# Engineering Change Notification

MS4, MS6 Products with optimized filter cartridge  
MS4-LF/LFR, MS6-LF/LFR, LF/LFR-DB-MINI product family

Project No  
233908

Project Title  
Design  
Optimization MS4,  
MS6 and DB-MINI  
filter cartridge

Previous Version	Future Version
old filter cartridge and separating disc	new filter cartridge and new separating disc

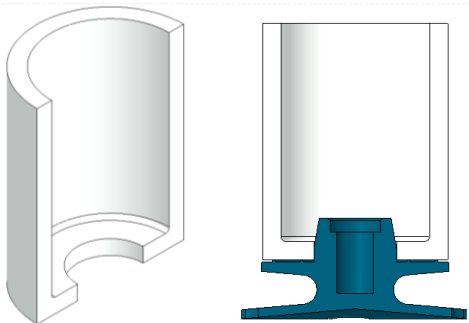
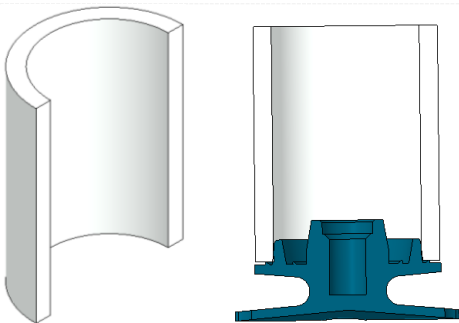
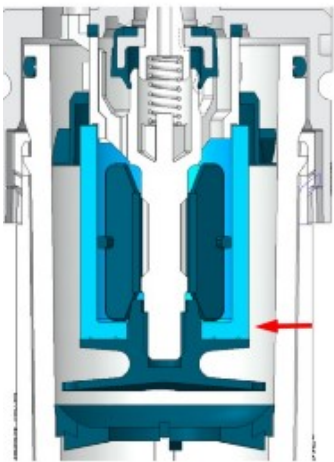
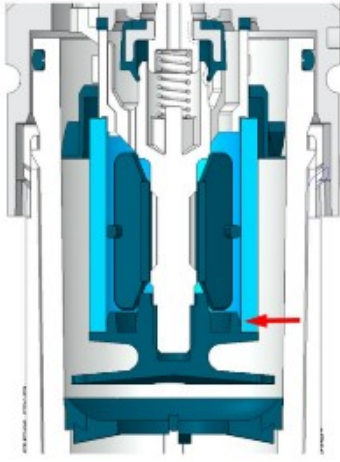
With the new filter cartridge design the **water removal efficiency will be significantly improved**. To reach this optimization the design were slightly changed (visible in the pictures).

All other technical values will keep the same quality.

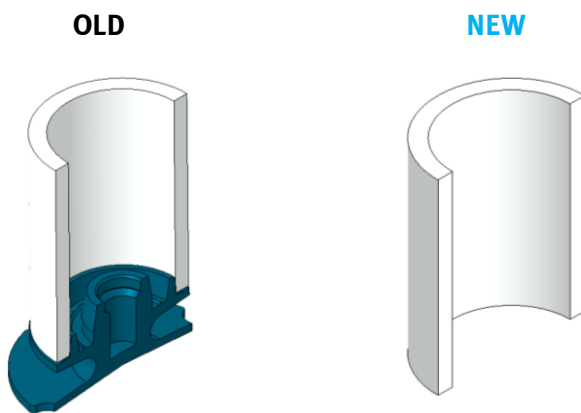
With the new design of the filter cartridge itself, we introduced a new separating disc which fix the filter cartridge. All given products and filter cartridges (old/ new) are completely interchangeable without any quality losses.

DB-MINI is not affected by change of separating disc.

**You can choose! Order the old part-no or the new:**

**Old filter cartridge e.g. 534500 MS6-LFP-E:**

- **new cartridge** (4893002) + **new separating disc** (8142370)

**New filter cartridge e.g. 8129061 MS6-LFP1-E:**

- only a **new cartridge** (4893002, without separating disc)

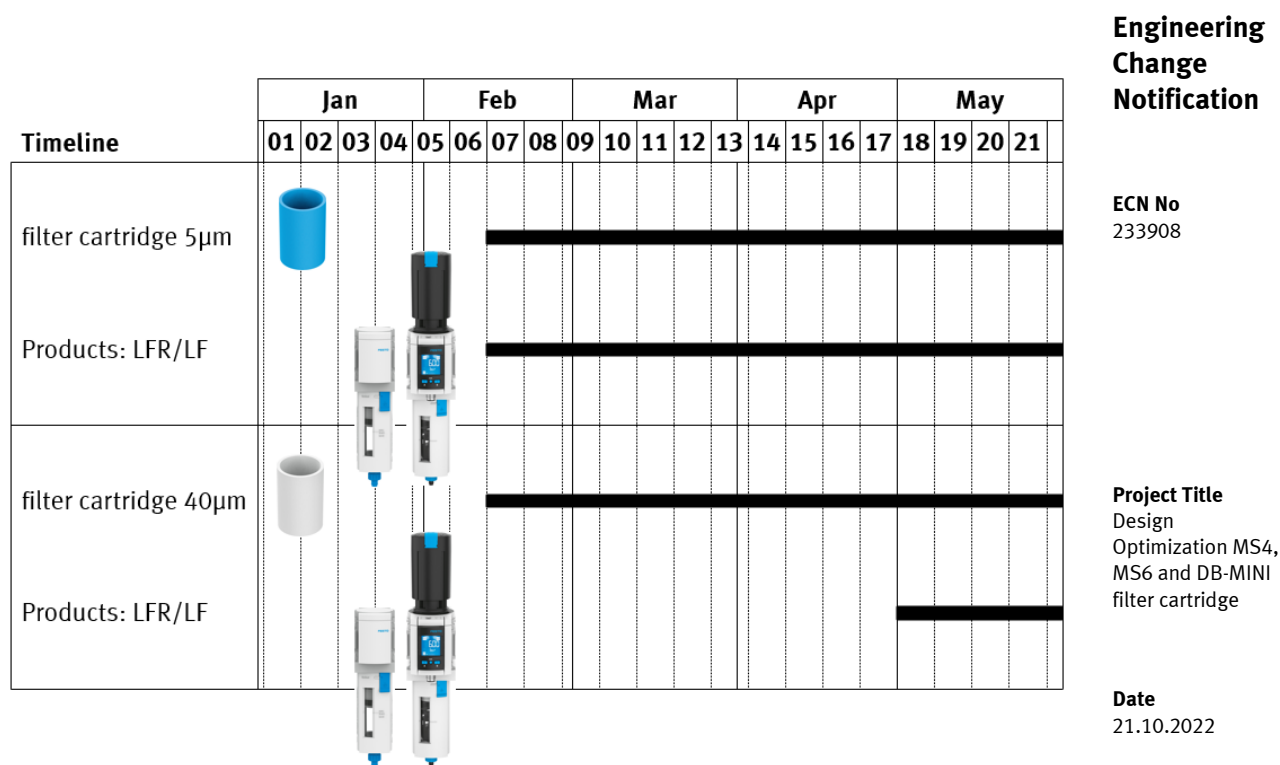
<b>OLD LFR/ LF/ FRC</b> (filter regulator/ filter)	<b>NEW LFR/ LF/ FRC</b> (filter regulator/ filter)
<b>OLD filter cartridge</b>	✓ <b>compatible</b>	✓ <b>compatible</b>
<b>NEW filter cartridge</b>	✓ <b>compatible</b> ✓ improved water removal efficiency	✓ <b>compatible</b> ✓ improved water removal efficiency
